BEAM ARRANGEMENT FOR NO 87

"Autania"

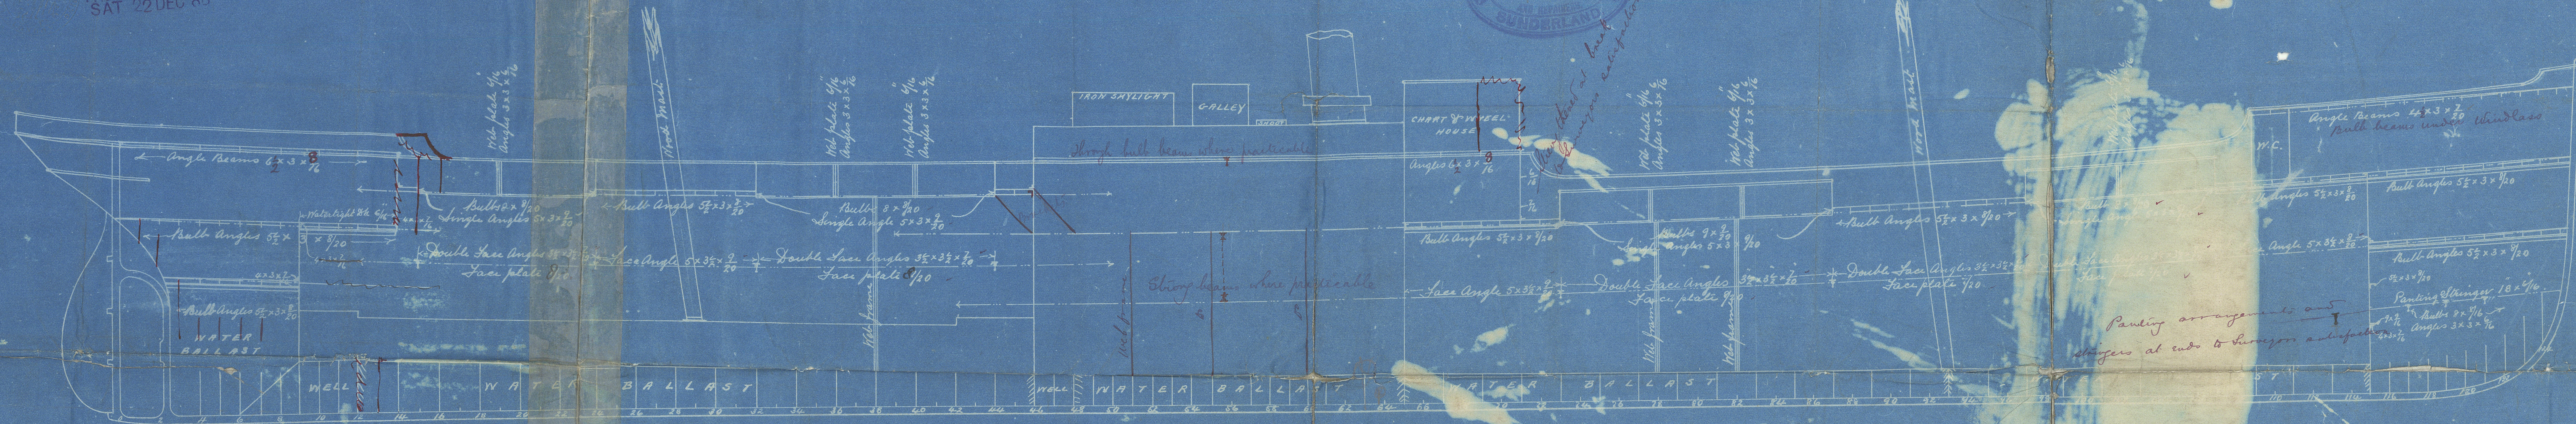
Strike of 1/4" plating at side of hatch increased 1/8" of an inch

Strike of 1/4" plating at side of Hatch increased 2/8" of an inch

Strike of main 1/4" plating increased 1/8" at sides of coamings

Strike of 1/4" plating at side of Hatch increased 3/8" of an inch

Strike of 1/4" plating at side of Hatch increased 1/8" of an inch
